FREDERICK COUNTY PLANNING COMMISSION

TITLE: **IHOP/Dairy Queen- Lot C6, Linganore
Town Center South – Commercial
Retail Center**

FILE NUMBER: **SP01-05 (AP SP260627, APFO A260622,
FRO F260623)**

REQUEST: **Site Plan Approval**
The Applicant is requesting Site Plan approval to
construct a 7,805 sq ft Restaurant on a 1.76-acre Site.

Figure 1 – Illustrative Plan

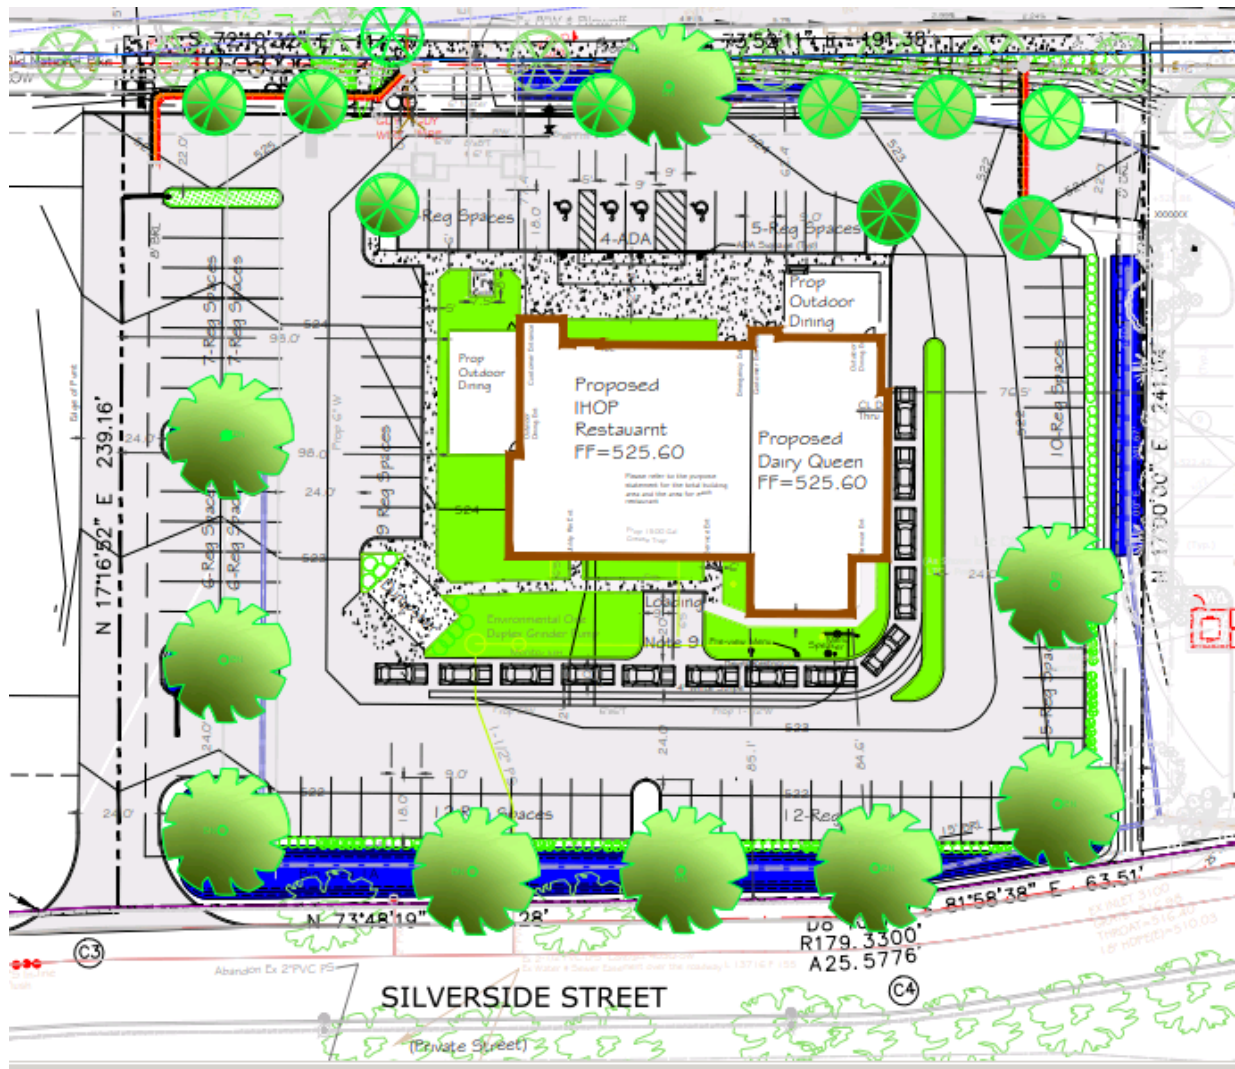
1. The setbacks (as detailed on Sheet 1 of the site plan) include the following; 15-foot front yard, 15-foot side yard to adjacent property line/8-foot side yard to internal property line, 15-foot rear yard with a maximum height of 60 feet. The setbacks provided meet or exceed the setbacks shown on the Preliminary Plan, as shown on note 8 of the cover sheet of the site plan.

1. **Access/Circulation:** One 24' wide entrance is proposed off of a shared access road called Silverside Street (private road). An interconnection with the adjacent parking lot to the east is also proposed. Loading and unloading is facilitated by two small loading spaces on the south side of the proposed building.
2. **Public Transit:** There is no local bus service for this Site.
3. **Parking:** Pursuant to Section 1-19-6.220 of the Zoning Ordinance for a restaurant 1

4. **Pedestrian Circulation and Safety §1-19-6.220 (G):** Internal sidewalks are provided within the parking area and surrounding the building. The site plan proposes a sidewalk connection to the adjacent sidewalk along Old National Pike.
5. **Bicycle Parking §1-19-6.220 (H):** Bicycle parking shall be provided as follows in accordance with the Zoning Ordinance:

Exhibit 1 – Site Plan Rendering

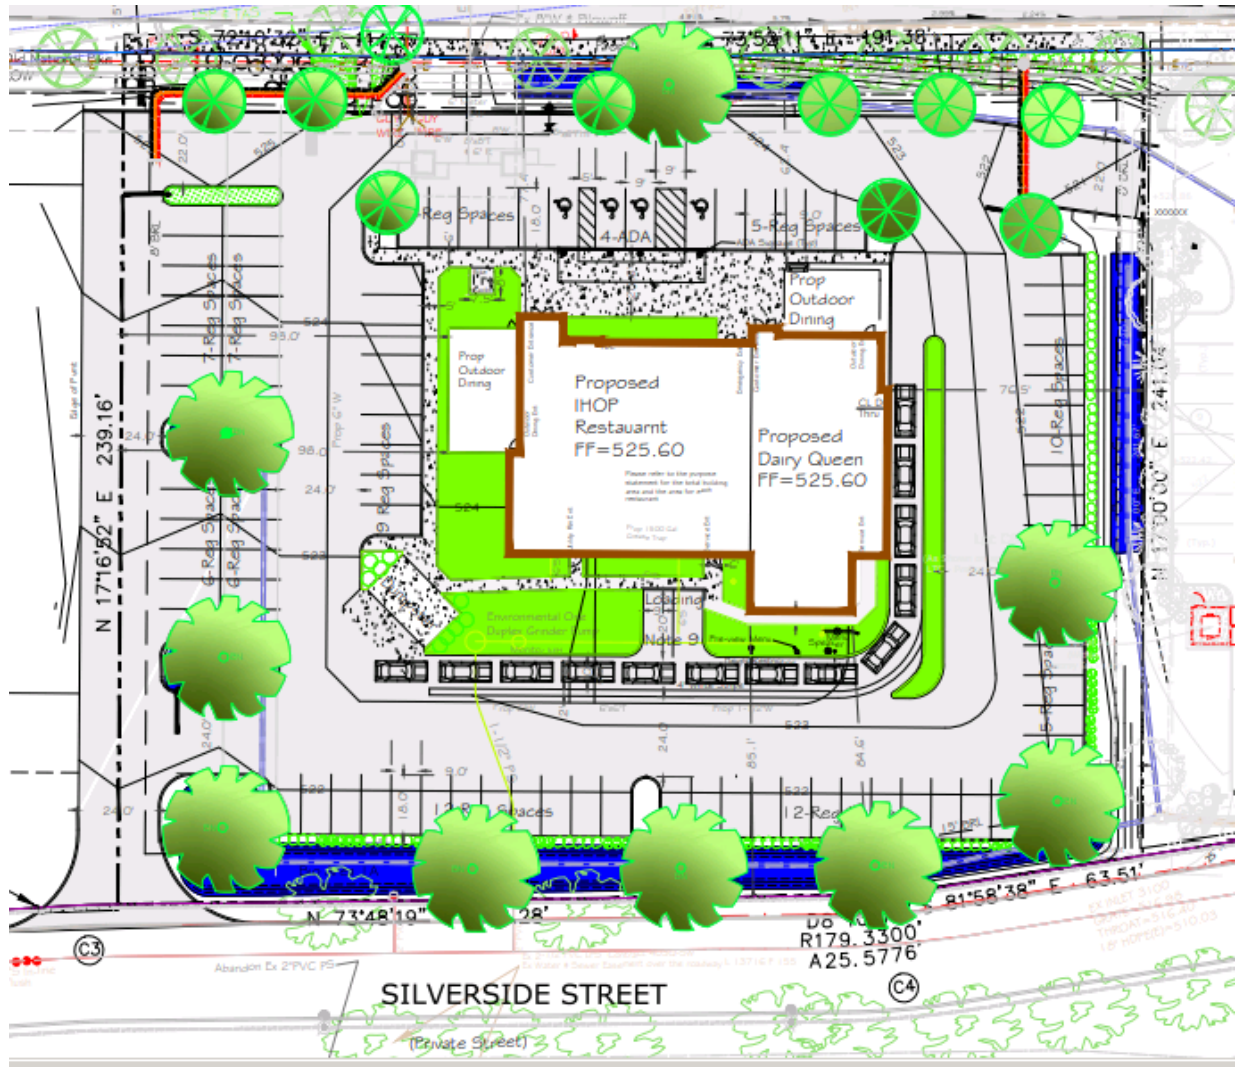
4. **Lighting §1-19-6.500:** The Applicant has provided a photometric plan documenting proposed lighting levels on the Site, which do exceed 0.5 foot-candles at, or beyond, the property boundaries. Per Section 1-19-6.500(D), lighting shall not exceed 0.5 foot-candles as measured from the property line. The Applicant has proposed light values to exceed 0.5 foot-candles as measured from the property line and a modification request has been submitted to allow for the increased light values at the property line. Per Section 1-19-6.500(B)(2) of the Zoning Ordinance, lighting fixtures in a PUD cannot exceed 14' in height. The Applicant has proposed 18' light poles, as measured from the ground to the point of illumination. A modification request has been submitted to allow the additional light height proposed. This modification request is consistent with the other modifications for 18' light poles that were approved in this same subdivision (Lot C3 and Lot C9).

1. Approval of a Lighting Spillover Modification Request under §1-19-6.220(D) to allow for lighting values to exceed 0.5 foot-candles at, or beyond, the property boundaries.
2. Approval of the modification of the 14-foot maximum height for light poles in a PUD Zoning district as provided in Section 1-19-6.500 to allow 18-foot tall pole mounted lights.
